David Garrett & Associates
Engineering and Geology

June 24, 2009

RE: Final Ground Water Monitoring Plans
C&D Landfill, Inc. Phase 2
NDENR Solid Waste Permit #74-07

Attachment

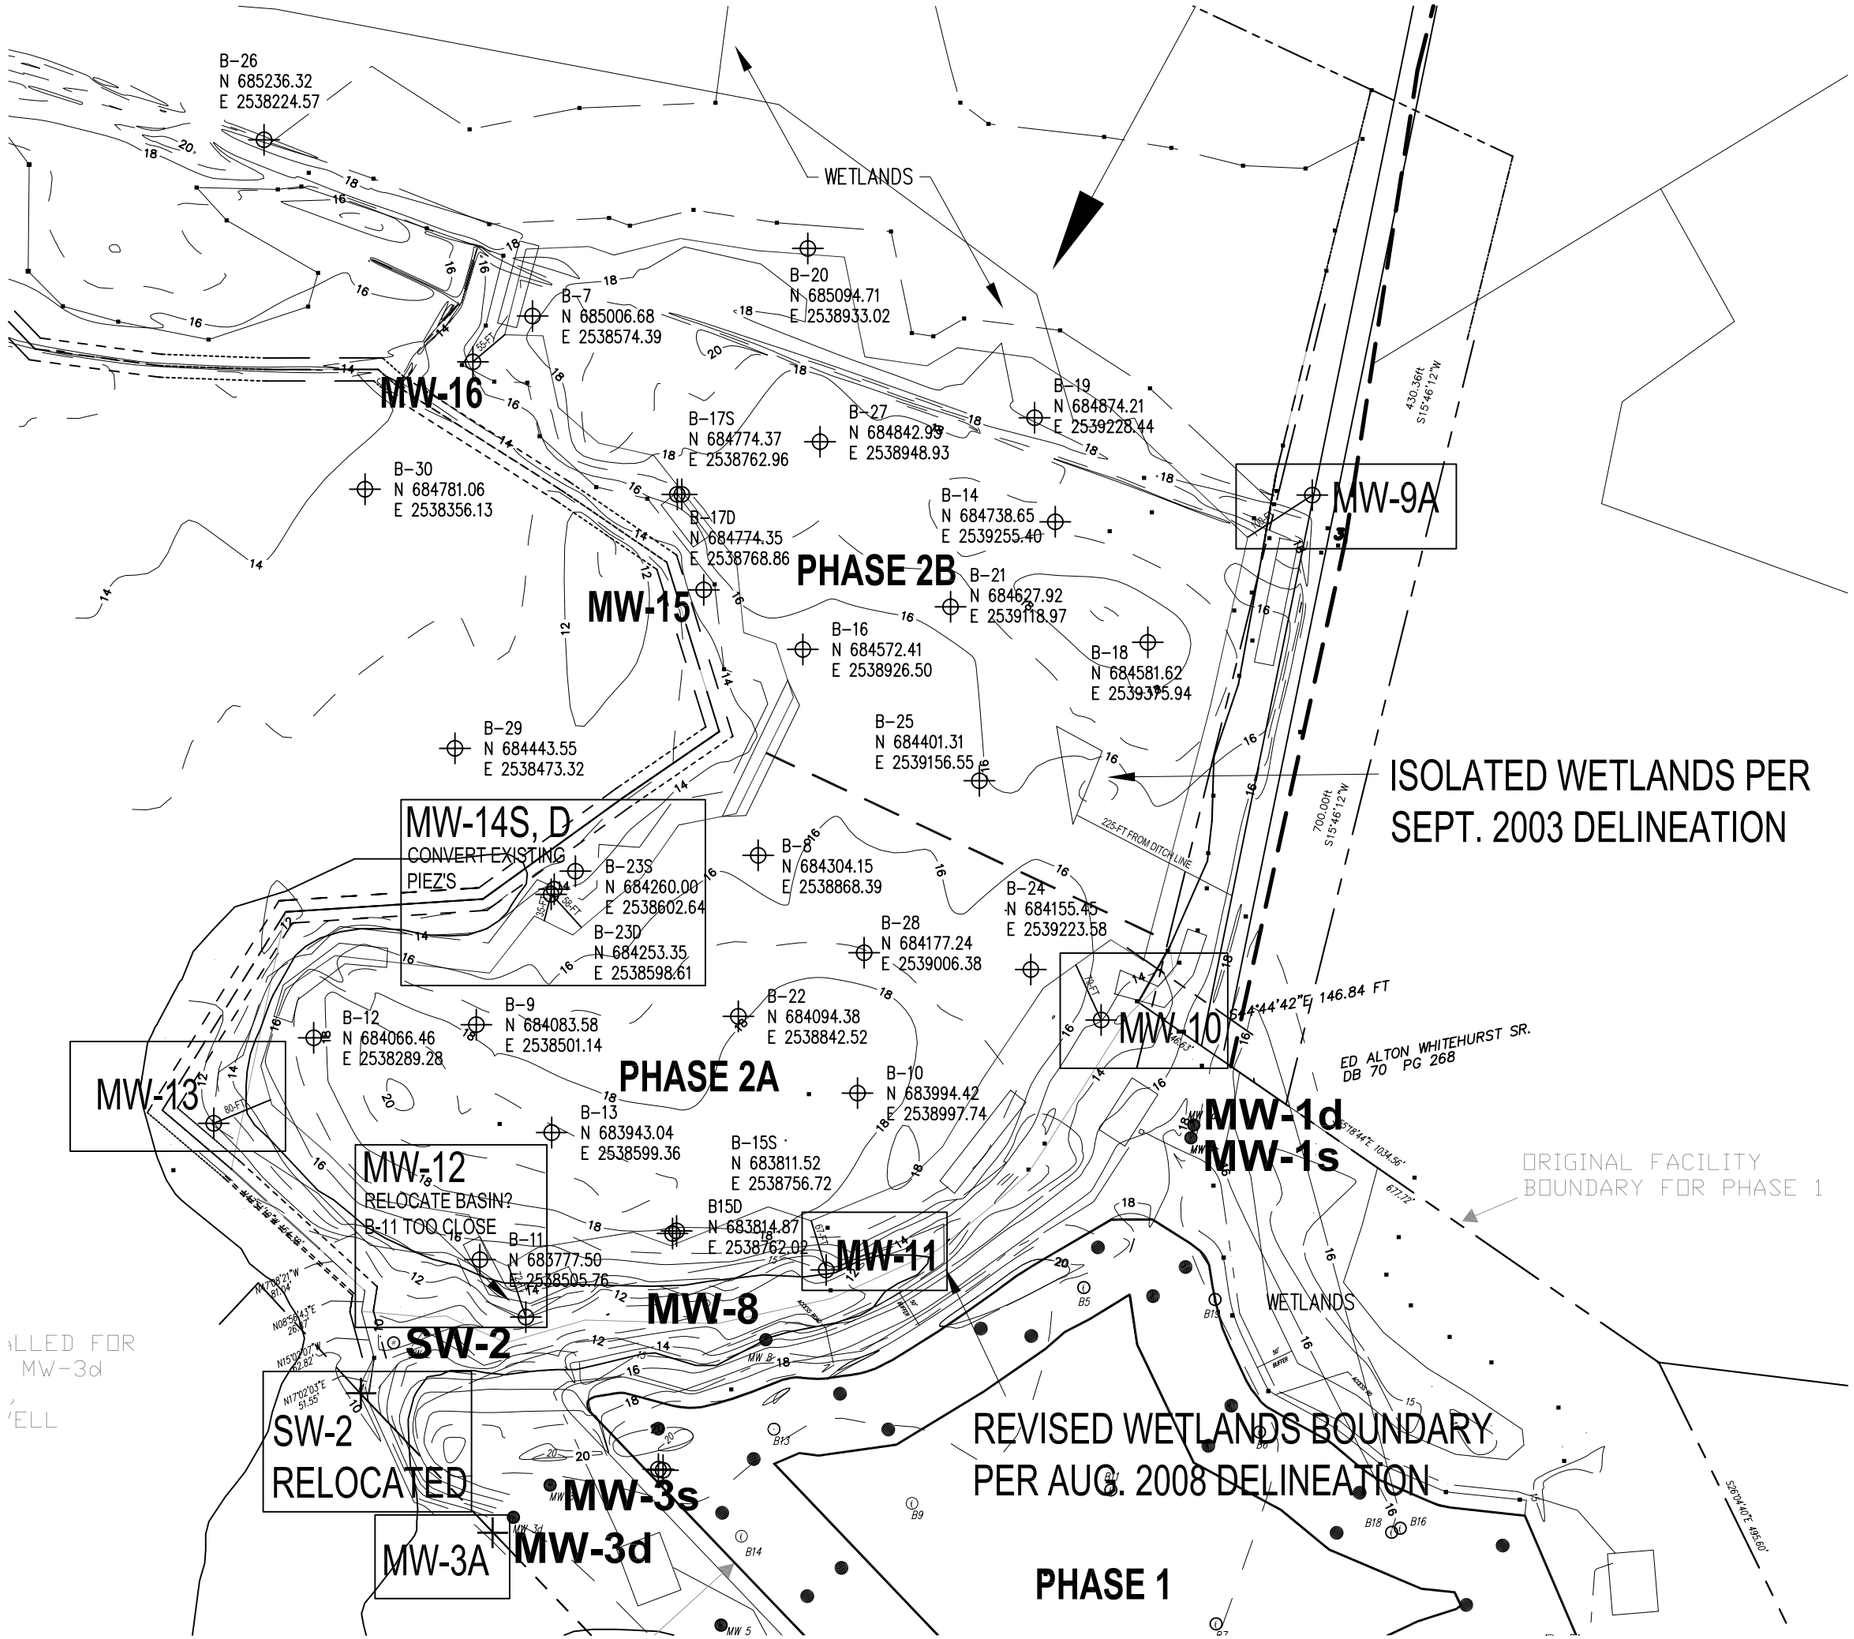
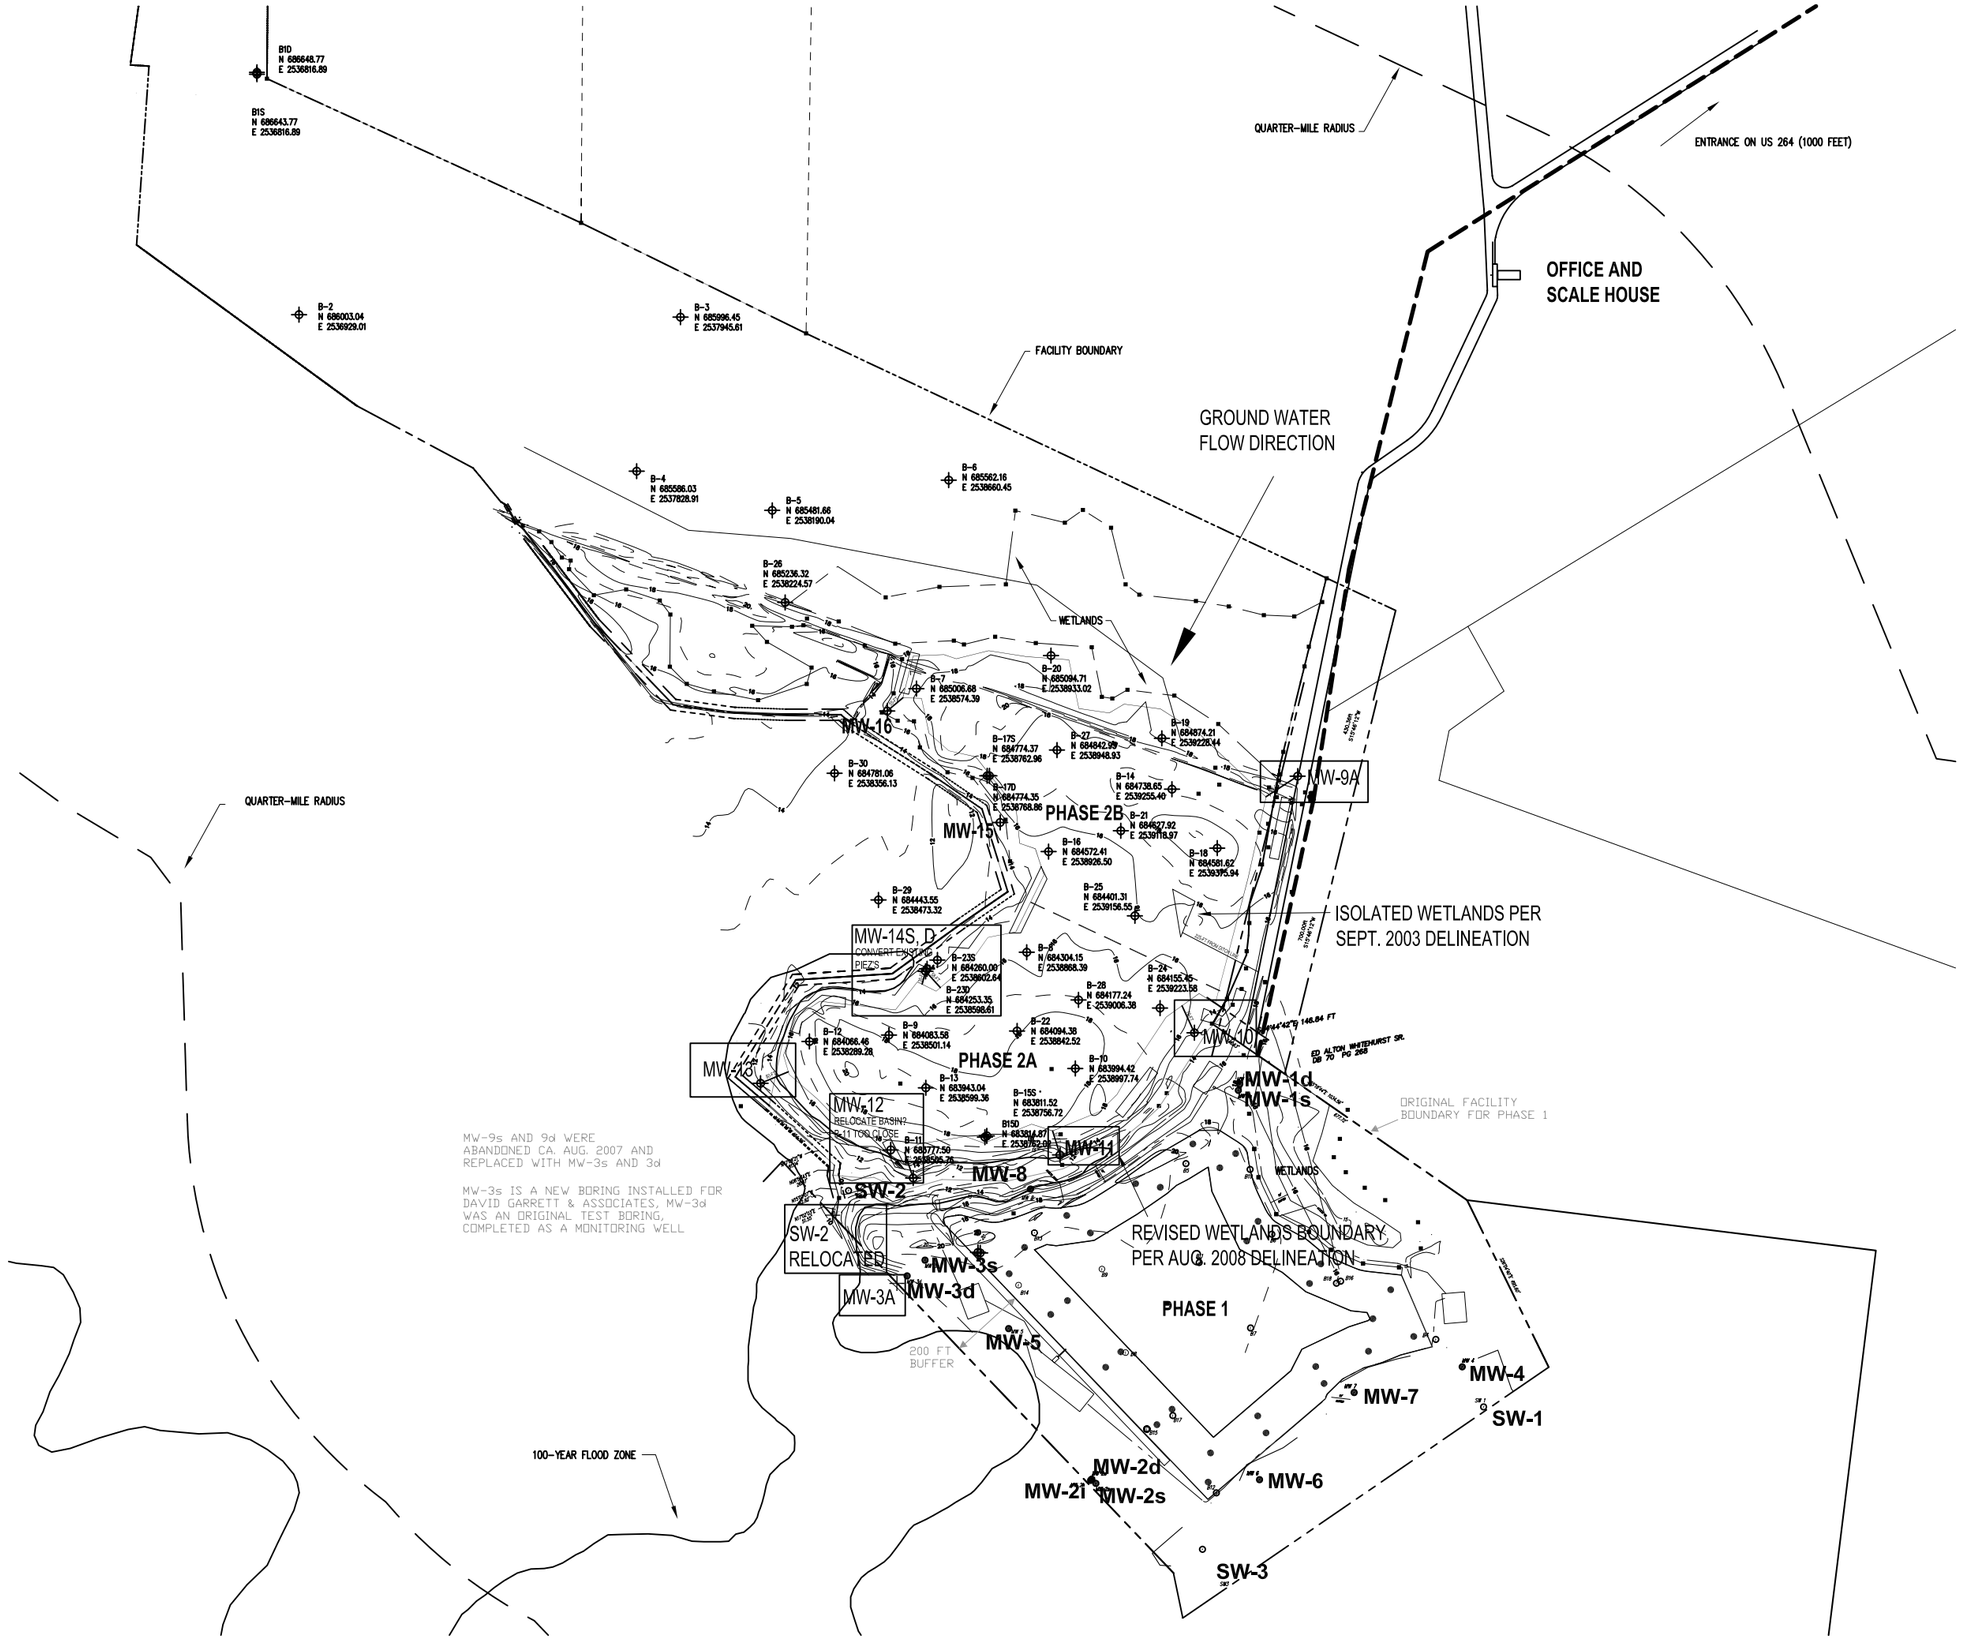
Our plans are to abandon all the piezometers associated with Phase 2 in preparation for the upcoming cell construction, except for a nested pair that is suitably located for conversion to permanent monitoring wells. Please refer to the attached Figure. We plan to abandon a total of twenty-two (22) piezometers in Phase 2, including B-7 through B-22 and B-24, B-25, B-27 and B-28. The pair that will be left in place will be B-23s and B-23d, which will be converted to MW-14s and MW-14d – these are near the location shown in the approved Water Quality Monitoring Plan. The depths and screen intervals of these piezometers is correct for monitoring this portion of the site, and I am satisfied that the construction is suitable.

At present, I would like to postpone installing and sampling the proposed MW-15 and MW-16, shown in the Figure, since the footprint served by these wells (Cell 2B) will not be constructed for at least 5 years. Other changes to the monitoring plan may be appropriate by then, thus we would like to amend the Water Quality Monitoring Plan (Appendix 5 in the May 2009 Design Hydro Report) to reflect this change. All other wells will be surveyed and activated into the detection monitoring program, with an anticipated semi-annual sampling schedule consisting of November and May sampling events, consistent with Phase 1.

- Finalized well locations for MW-9A through MW-13, subject to minor field adjustment
- Conversion of piezometers B-23s and B-23d to wells MW-14s and MW-14d
- Postponement of installing MW-15 and MW-16 until future Cell 2B is built
- Relocating surface water sampling location SW-2 to cover both phases (see Figure).
